STATE OF MAINE
DEPARTMENT OF TRANSPORTATION
16 STATE HOUSE STATION
AUGUSTA, MAINE 04333-0016

August 16, 2022
Subject: Interstate95 Bridge projects
and north main street roadway
reconstruction
State
WIN:023603.00,023607.00,023609.
00 &023613.00
Location: **Pittsfield**
Amendment No. 1

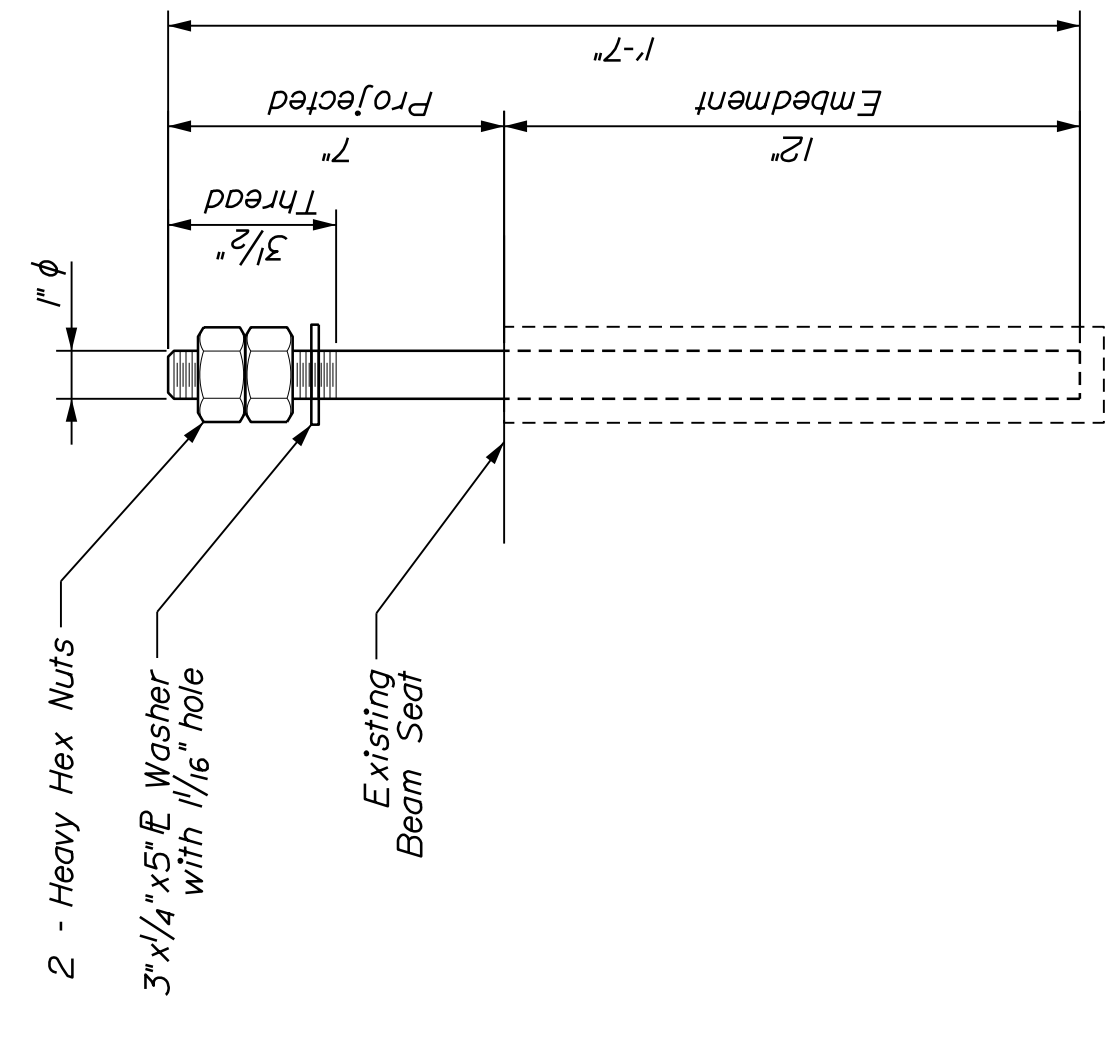
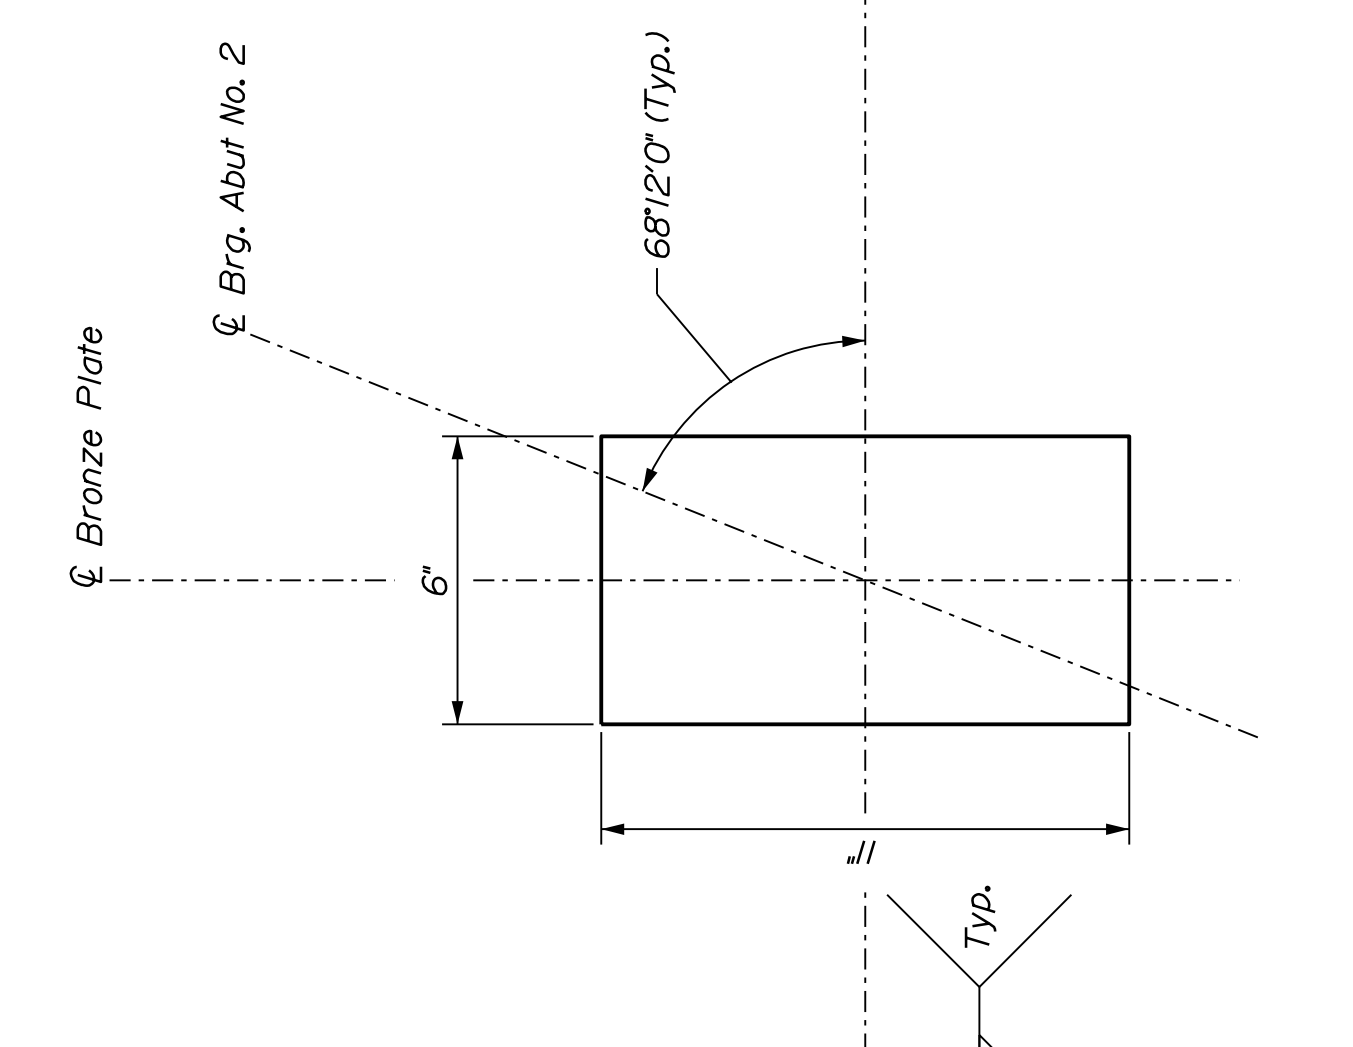
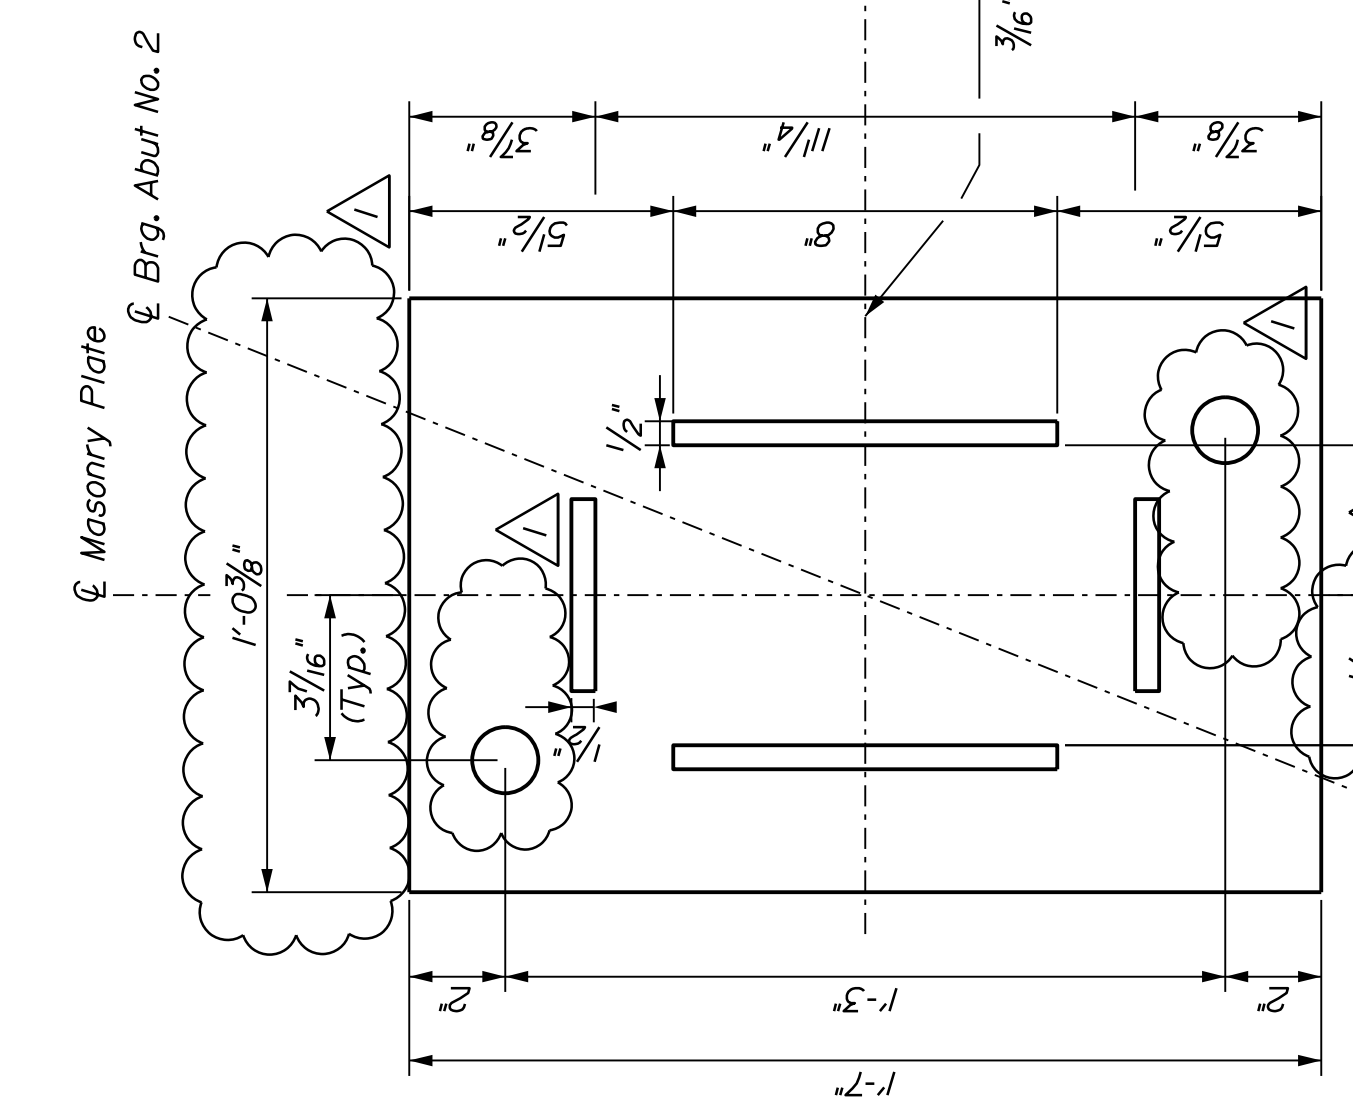
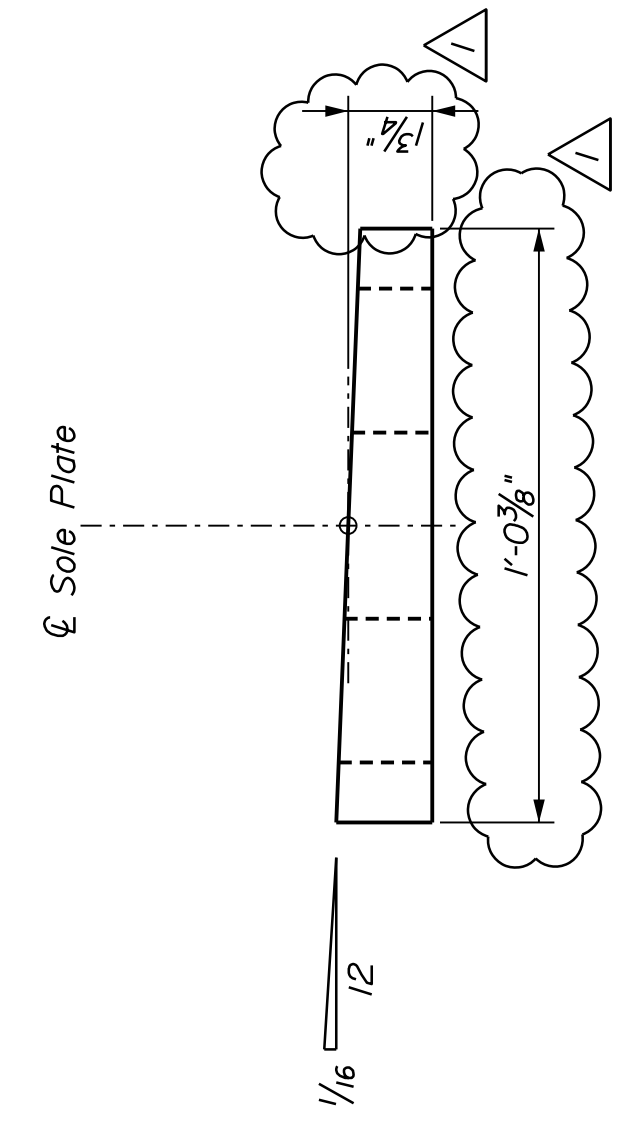
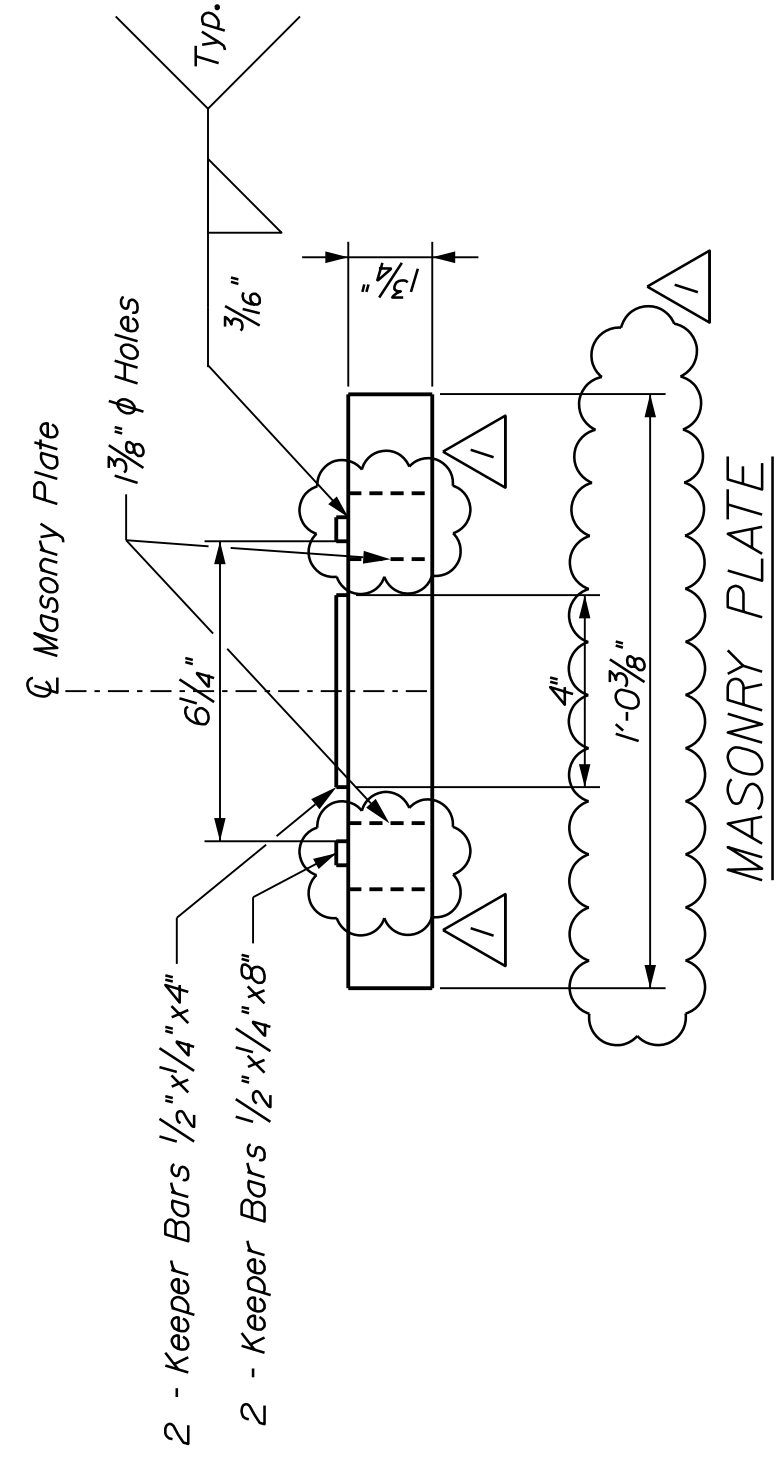
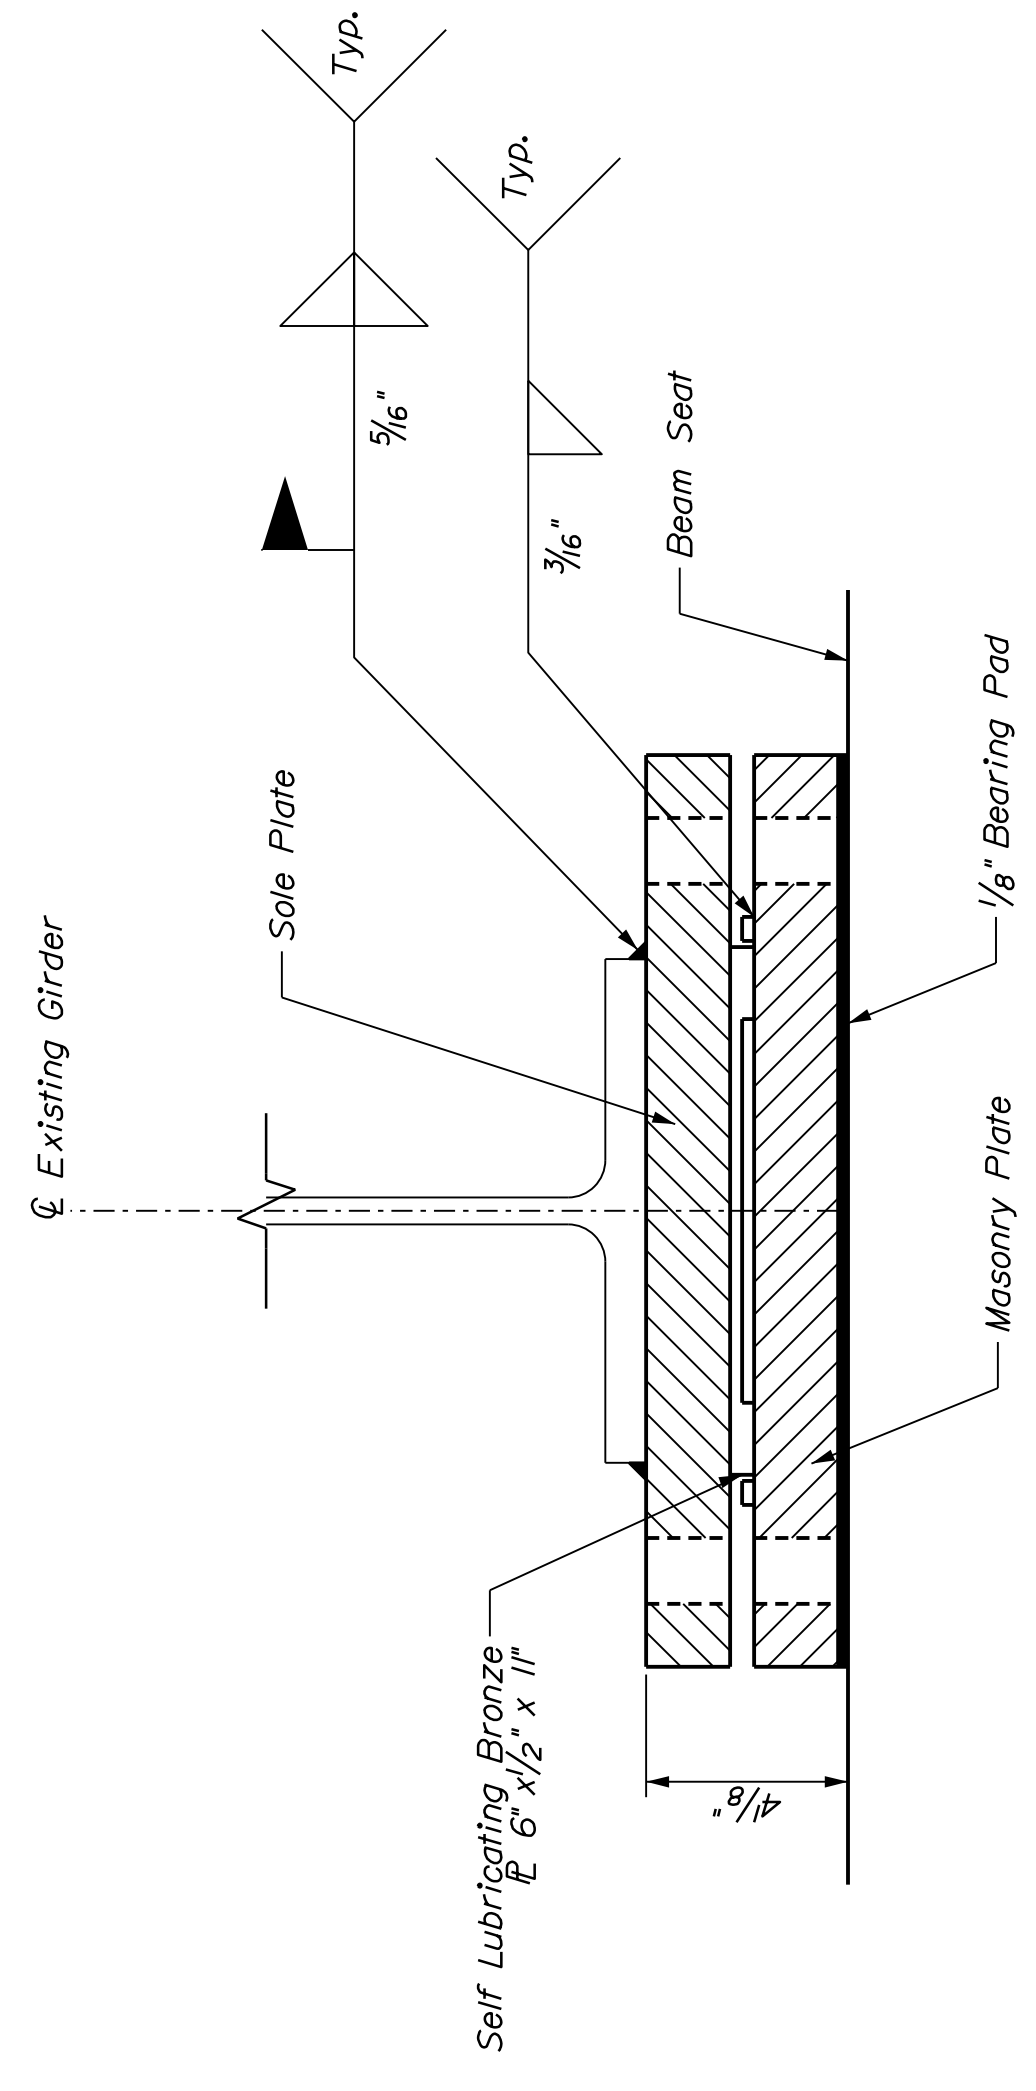
REMOVE plan sheet 96, “STEEL BEARING DETAILS” and **REPLACE** with the attached revised plan sheet 96 “STEEL BEARING DETAILS”.

Question: Regarding the I-95 SB North Main Street bearing replacement items and associated structural support, if none of the bridge seats are being replaced, and bearing anchor locations are not being adjusted from the original locations, is it MDOT’s expectation that the existing diaphragm located at centerline of bearing will be removed in order to facilitate coring and removing the existing anchor rods as well as drilling and installing the new anchor rods? If so will this work be paid for under the associated temporary structural support item?

Response: Please see aforementioned changes to the bid documents for more information on the bearing installation. If any structural steel work is required to facilitate the installation of the replacement bearings on bridge #1445, payment will be considered incidental item 524.301 Temporary Structural Support.

- Masonry plates, sole plates, and keeper bars shall meet the requirements on ASTM A709/A709M, Grade 50. Anchor rods shall meet the requirements of ASTM F1554, Grade 105 and shall be swaged on the embedded portion of the rod.

- Contractor shall verify bearing dimensions to ensure they match existing bearing dimensions.
- Anchor rods shall be drilled and grouted into bearing pedestals. Grout shall be from MaineDOT approved grout from Qualified Products List.
